Randwick Local Planning Panel (Public) Meeting

Development Application Report No. D36/22

Subject: 3 Surfside Avenue, Clovelly (DA/774/2021)

Proposal:	Proposed demolition of existing dwelling, construction of dual occupancy with shared garage, associated driveway and landscape, pool to the rear yard, and strata subdivision.
Ward:	North Ward
Applicant:	Astra Wu
Owner:	Big Yellow Developments Pty Ltd
Cost of works:	\$3,128,326
Reason for referral:	More than 10 unique submissions in objection

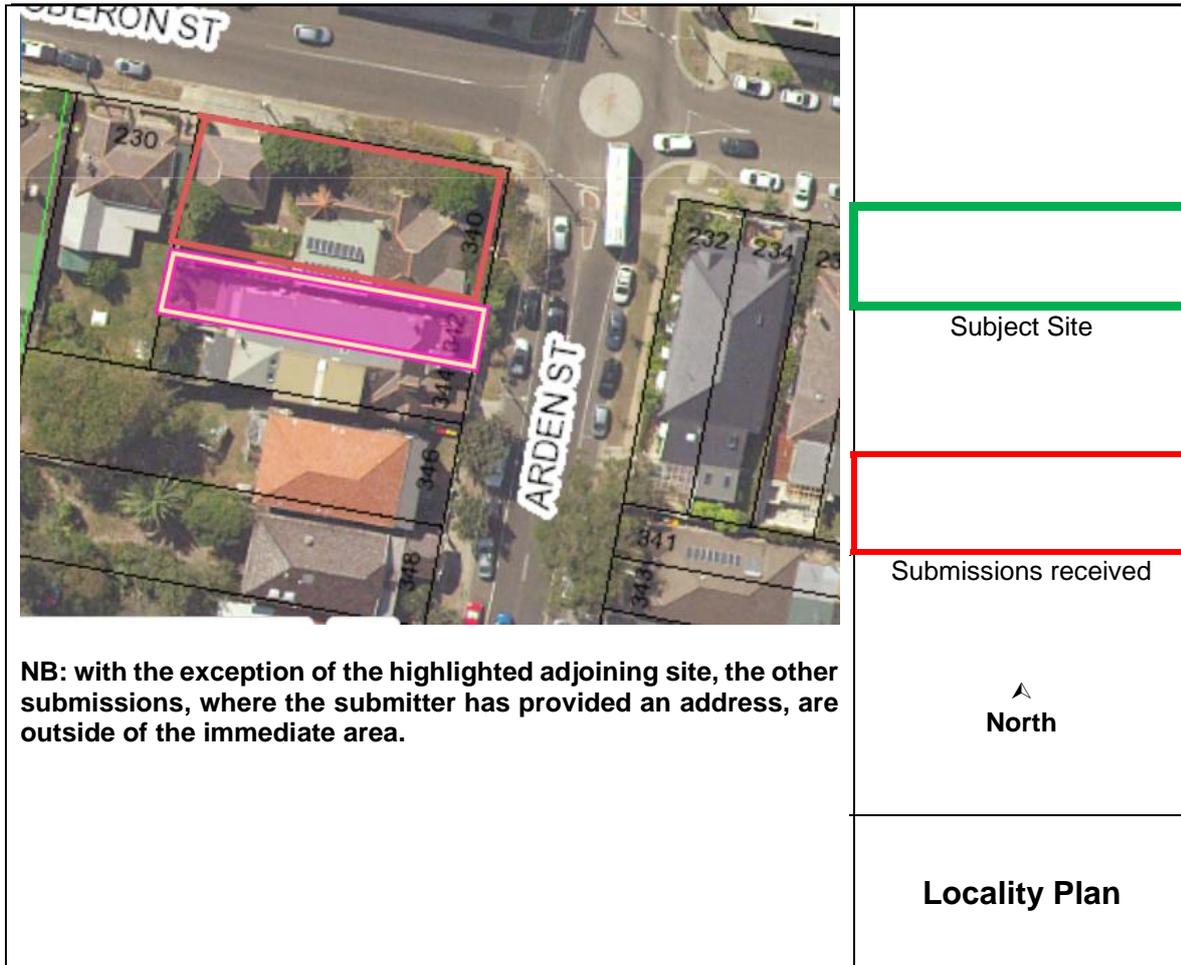
The proposal seeks development consent to delete reference in condition 3. a. that requires the proposed first floor addition to have a minimum rear setback consistent with the adjoining semi-detached dwelling at No. 344 Arden Street, Coogee.

There is no predominant rear building line noting that a non conforming flat building in the R2 zone exists in the near vicinity and the site to the north at 340 Arden Street has a secondary street frontage to Oberon Street which also contains dense screen planting along its northern and southern setbacks and has substantail structures in its rear yard.

The adjoining property to the north 340 Arden Street has a large outbuilding in the rear yard and a large hedge which prevents the direct view of the proposed rear upper level from the street and public domain. See figure 3 above.

- A. That the RLPP grant consent under Sections 4.16 and 4.17 of the Environmental Planning and Assessment Act 1979, as amended, to modify Development Consent No. DA/123/2021 by deletion of Condition 3. a. in relation to the rear setback of the dwelling at 342 Arden Street, Coogee, in the following manner:
- 1) Delete Condition 3. a.
